UNITED STATES PATENT AND TRADEMARK OFFICE

APPLICATION NO.	FILING DATE	FIRST NAMED INVENTOR	ATTORNEY DOCKET NO.	CONFIRMATION NO.
09/719,323	01/04/2001	Toshikazu Ura	F-6768	7228

Office Action Summary

DETAILED ACTION

Sept. 25, 1973 JEAN-PIERRE CAILLEY 3,761,314
HIGH DISCHARGE RATE ELECTRIC CELLS AND BATTERIES
Filed June 22, 1971 3 Sheets-Sheet 1

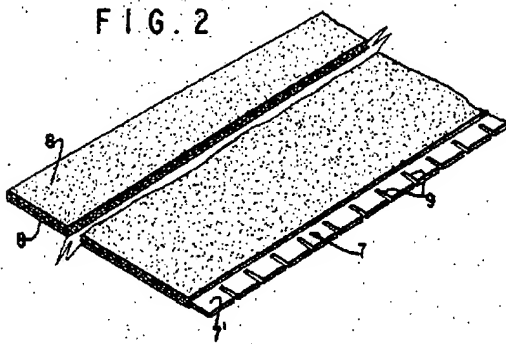
In claims 9 and 14, the limitation “a top edge portion of the at least one first current collector is bent orthogonally with respect to the axis of the spiral and forms a continuous spiral edge” is not in the original disclosure. The original disclosure does not show a continuous spiral edge that is bent orthogonally with respect to the axis of the spiral because there is no top view or bottom view of the electrode plate group in the Figures or any mention in the specification that a top edge of either the first current collector or the second current collector forms a continuous spiral edge bent orthogonally with respect to the axis of the spiral. The method depicted in Figure 2 does not ensure a top edge of the first current collector that forms a continuous spiral edge bent orthogonally with respect to the axis of the spiral.

As admitted by the applicant on page 15, lines 1-5 of the specification, folding may occur to some extent using the method depicted in Figure 2. Since there is no mention of slits being made at the edge of the current collector, the folding of the edge of the current collector into a plane will not result in a continuous spiral edge with a perfectly flat plane of 90°. Furthermore, folding of the edge onto itself may result in a discontinuous spiral edge. The edge of the current collector must be slit in order to form a continuous spiral edge with a flat plane of 90° as disclosed by Jean-Pierre Cailley in Figures 2 and 3 and reproduced below (US 3,761,314).
